1. App # 2023-5143; Eastwood Final Plat; AMH Development, LLC

RE: Eastwood Reserve Subdivision, Final Plat, Phase 1

Date: April 12, 2023; Revised April 26, 2023
To: Mr. Eric Meyer, Director of Development
From: Ryan Andrews, City Engineer
Subject: Staff Report for: Eastwood Reserve Phase 1 Final Plat
Copies: Joseph Begeny, Mayor; William Dorman, Public Service Director

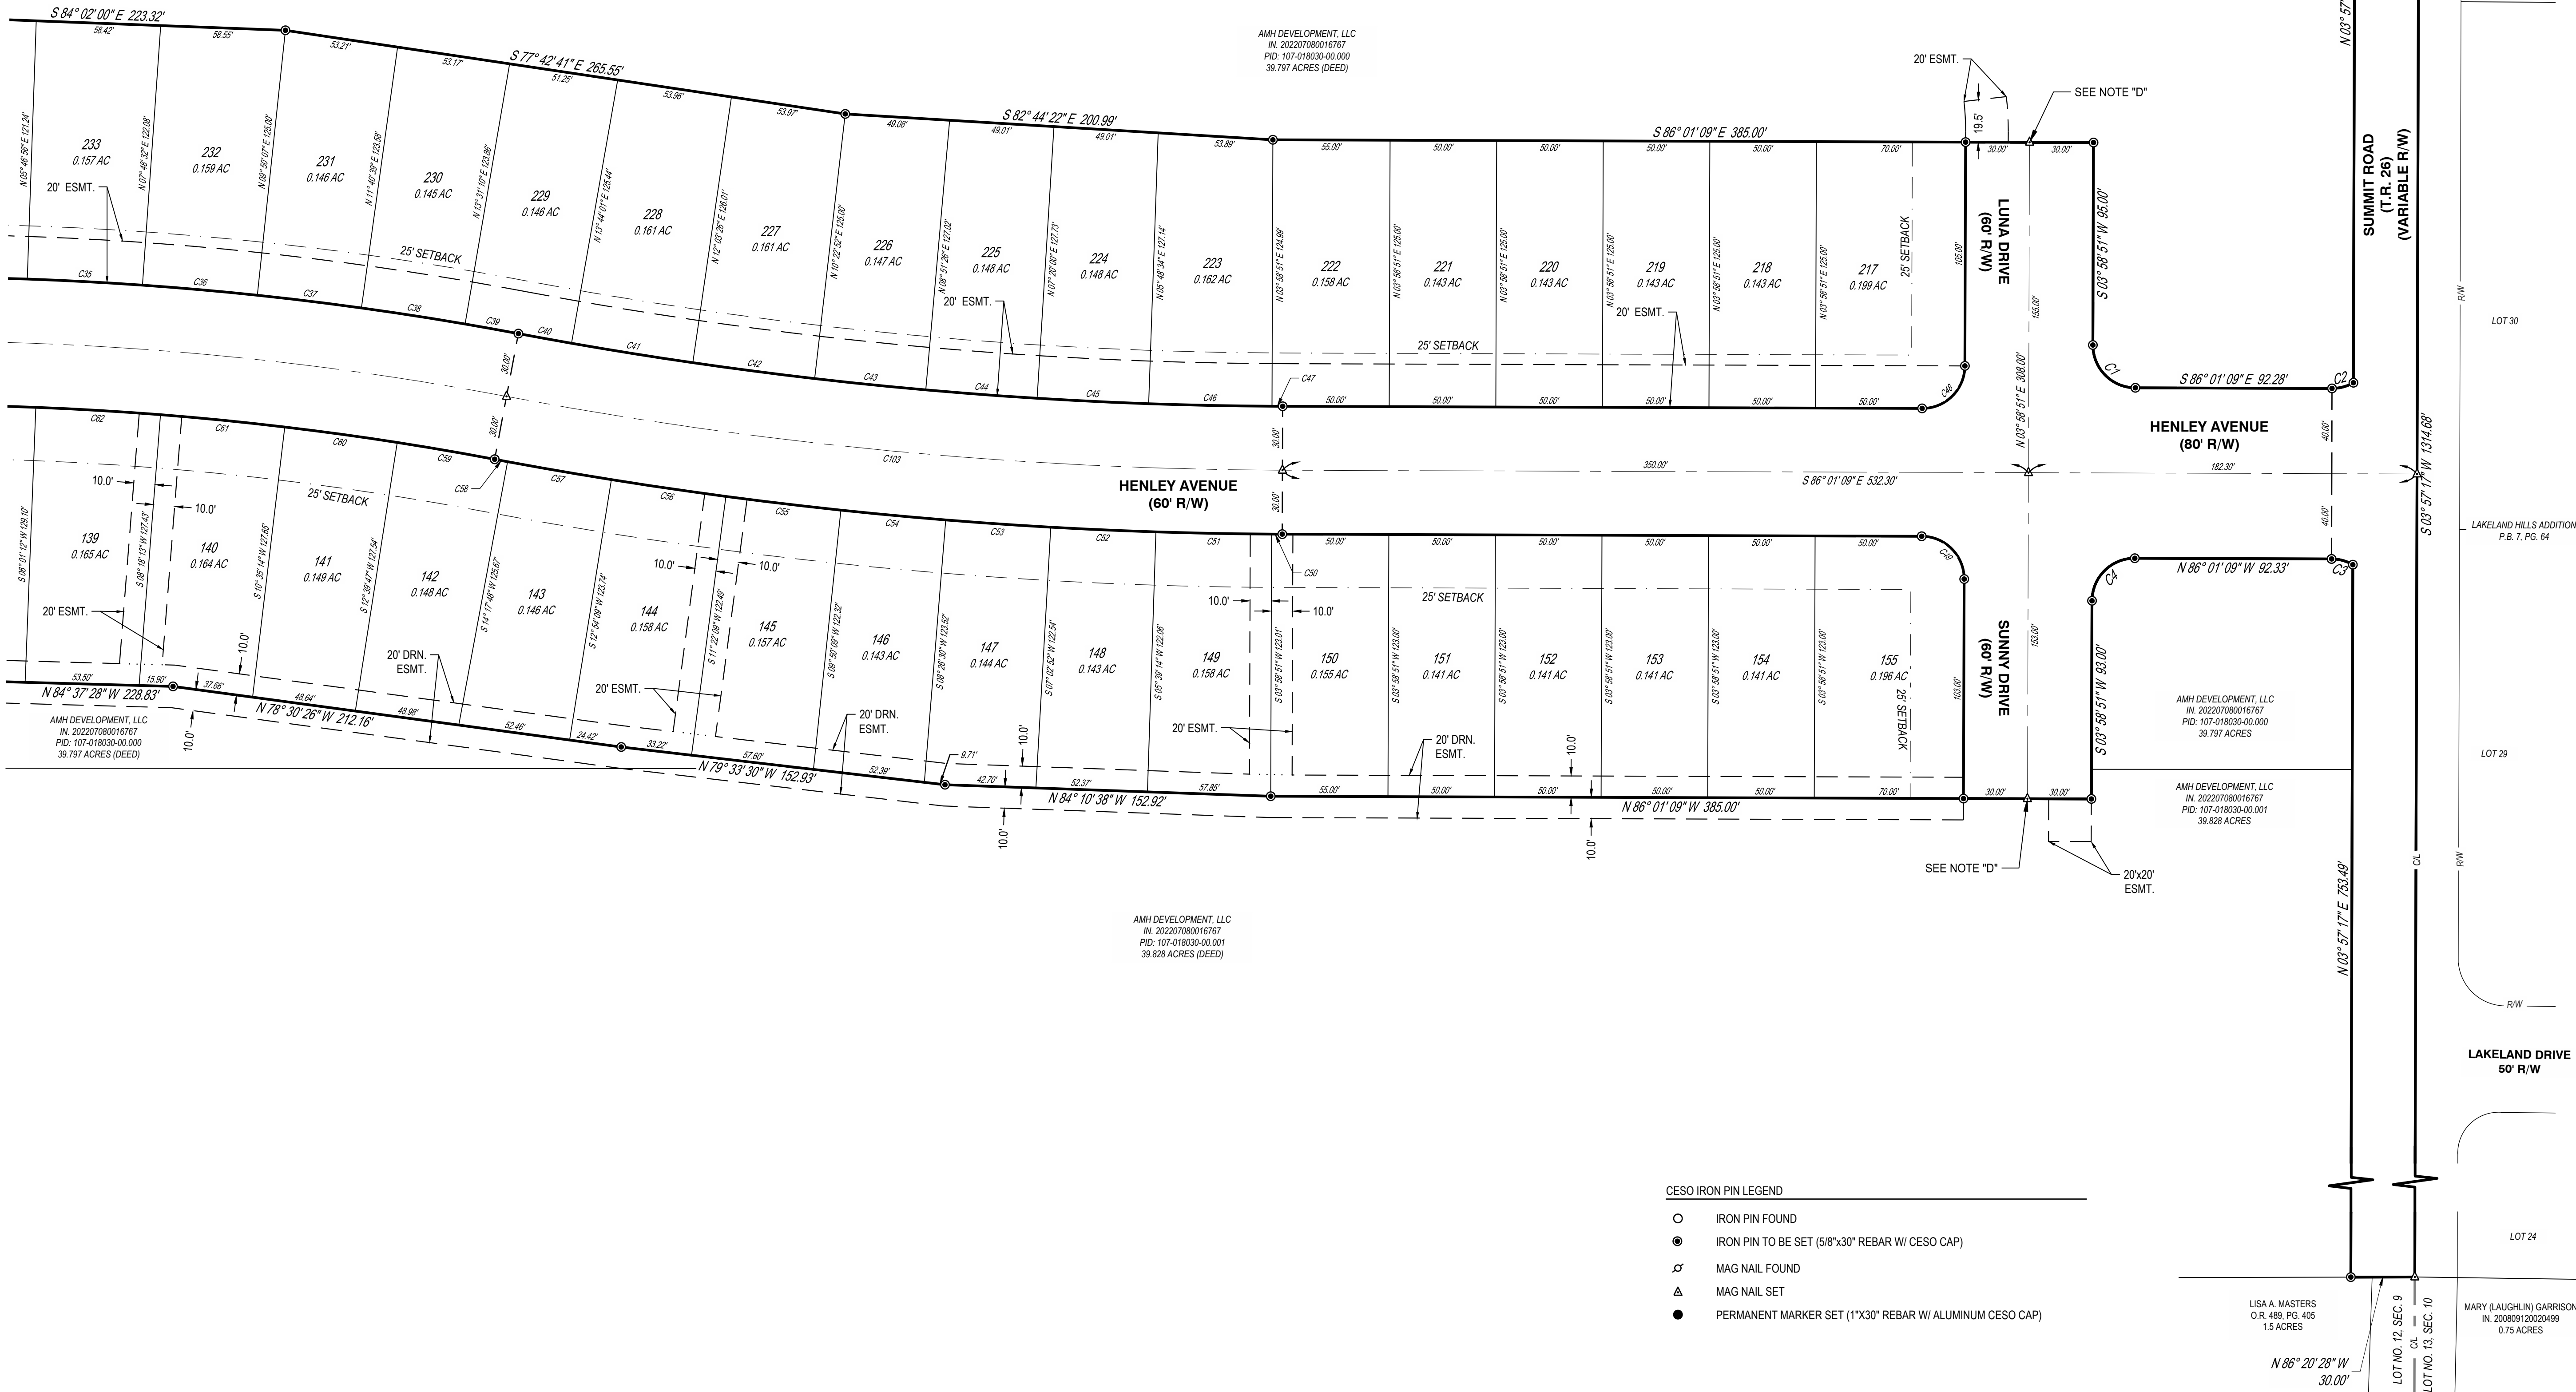
8. At the bottom of page, Sheet 2 indicates the project acreage of 39.828 while Sheet 3 indicates an acreage of 39.996. Please clarify.
9. Top right of page, please provide the dimension between the R/W and the center line.
10. Call out Summit Road on plan sheet.
11. Move the Summit Road label inside of the R/Ws.
12. Replace the "40'" label with the word "variable".
13. Add the MAG SET at the intersection of Henley Avenue and Summit Road.
14. Remove arbitrary line between the center line and the R/W south of Henley Avenue.
15. Will there be a setting pin placed on the center line of Summit Road?

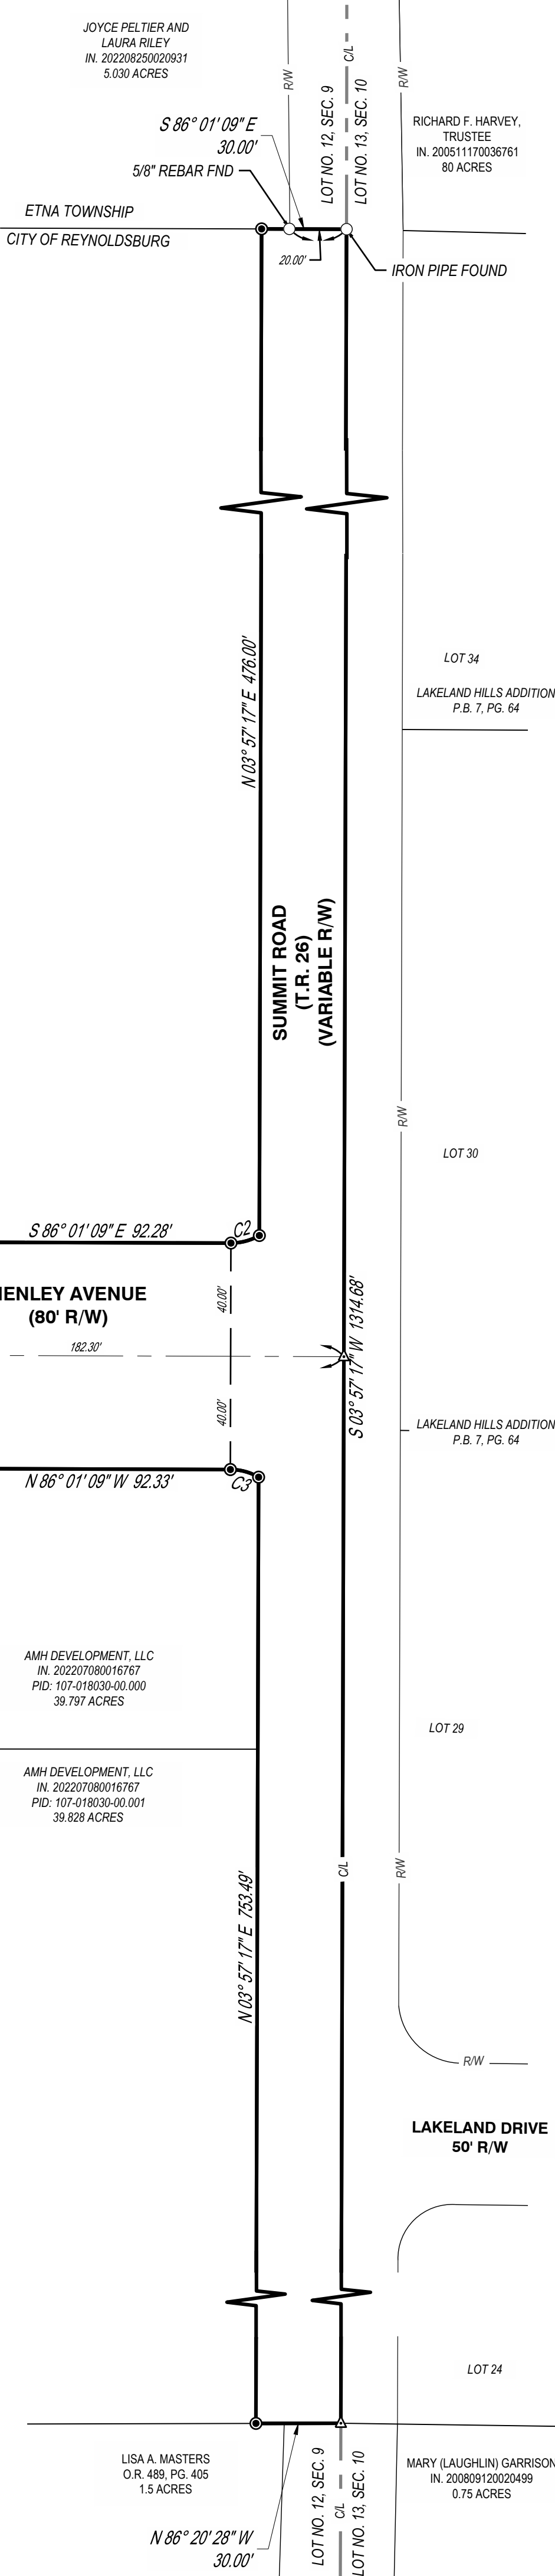
16. Remove the arbitrary line in the upper left corner of sheet.
17. Label the drainage easement (and tie down) the area north of lots 248 and 247.
18. Use dash lines to extend easement lines where indicated on plan sheet.

19. Label drainage easement on the northwest corner of Park Place North.
20. Sheet 2 indicates there are 39.828 acres to this project. Please clarify.
21. In 'NOTE "C"' for acreage breakdown, please add 'RESERVE PHASE 1' after EASTWOOD.

22. Add an "S" on the end of 'NUMBER' to make it plural.
23. Call out distances from center line to R/W on Park Place (as was done on Henley Ave).
24. A temporary turnaround easement is needed at the eastern terminus of Lucy Drive.

25. In NOTE "H":
 - please replace the word 'IS' with "ARE".
 - Add the words "THE OWNERS OF" after the words 'HOMEOWNERS ASSOCIATION COMPRISED OF'
 - Add the words "TITLE TO THE" between the words 'SIMPLE' and 'LOTS'.

- Add the words "PHASE 1" at the end of the paragraph.

4

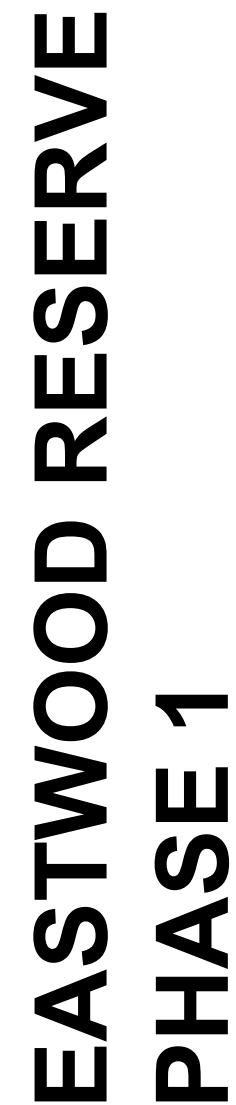
26. The drainage easement in Reserve "A" needs to be tied down.
27. To the west of Park Place South above the 15' access easement, the PGU shows the 20' easement as a drainage easement, but this only shows it as an easement.

28. At the 15' access easement, the plat plan shows it to be a drainage easement as well as an access easement, but it is only an access easement on the PGU, not a drainage easement as well.

29. Use dash lines to extend the easement lines on Lots 125 and 126.
30. Include an easement call out to the west of Lots 125 and 126.
31. Call out the 20' easement on north Lucy Drive.

32. Call out the 20' easement to the east of Lots 1-6.
33. Call out distances from center line to R/W on Park Place South as well as Lucy Drive.
34. Should turnaround easement be called out prior to public street R/W extension completion?

35. Note that platting of the continuation of Sunny Drive to connect to Little Jordan Way is being handled separately.
